PUBLIC MEETING RE: SD-23-0003 RODRIGUEZ TDR/PUD SKETCH PLAN

Docket SD-23-0003: Rodriguez TDR/PUD Sketch Plan

Request: Request for a Sketch Plan review for a Transferred Development Rights (TDR) / Planned Unit Development (PUD) receiving site consisting of a total of four residential lots on approximately 39.5 acres.

Location: 6184 Niwot Road, located at the southwest corner of Niwot Road and N. 63rd Street, in Section 34, Township 2N, Range 70W.

Figure 4. Subject parcel with existing fire hydrants indicated by red Xs.

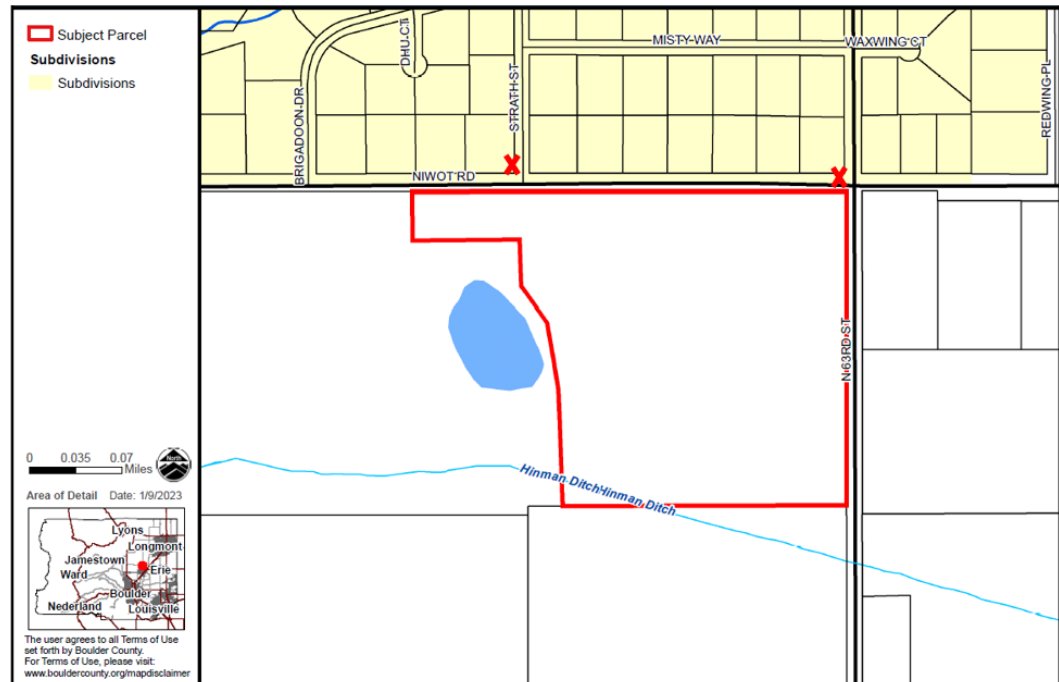
Currently, there is a single fire hydrant located on the north side of Niwot Road just west of N. 63rd Street and one on the west side of Strath Street just north of Niwot Road (see Figure 4 below). Per the re-referral response from the Boulder Rural Fire Protection District, since the proposed parcels would be within 1,000 feet of a hydrant, no additional cistern will be required.

This application did not include any information or proposal for meeting the requirements of Section 7-1100; as such, staff has not included any analysis related to this specific Section. However, staff find that the specifics for compliance with Section 7-1100 of the Code are details that can be developed prior to the submission of any application for Preliminary Plan review.

Therefore, with the inclusion of the required Fire Protections under Article 7-1100 of the Code in any Preliminary Plan Review, staff find this criterion can be met

Figure 5. Revised Sketch Plan with ECA indicated in purple.

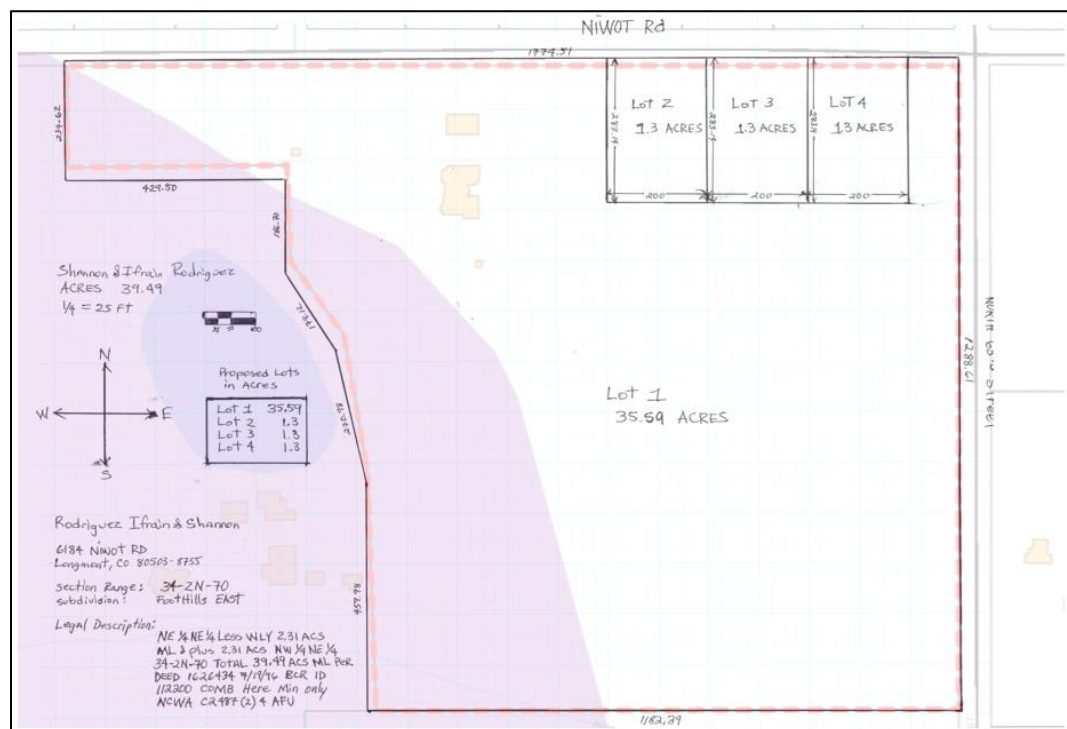
As shown in Figure 3 above, portions of the subject property are within the Boulder Valley Ranch/Beech Open Space Environmental Conservation Area (ECA). Based on

the revised Sketch Plan, the northwest portion of Lot 1 would be within the mapped ECA (see Figure 5 below).

In 2017, the Parks and Open Space Natural Resources Planner submitted a referral response related to the Site Plan Review for the existing residence (SPR-17-0091). The response stated that the mapped boundaries of the ECA were created with “a broad brush,” and that “the on-the-ground boundary in the subject area would extend to 63rd Street.” Based on this information, staff find that the entire parcel has similar environmental values to the mapped ECA; as such, staff also find the amount of environmentally sensitive land which would be impacted by the proposed subdivision is likely greater than that indicated in Figure 5. Staff find that the establishment of building envelopes, landscaping requirements, and other site design restrictions could potentially minimize or mitigate these impacts. However, as no such envelopes, landscaping, or other site design proposals have been submitted at this time, staff cannot provide any analysis as to the potential effectiveness or appropriateness of any such measures at this time. Potential mitigation measures (including, but not limited to, building envelopes, landscaping requirements, and other measures as appropriate) must be included in any application for Preliminary Plan review.
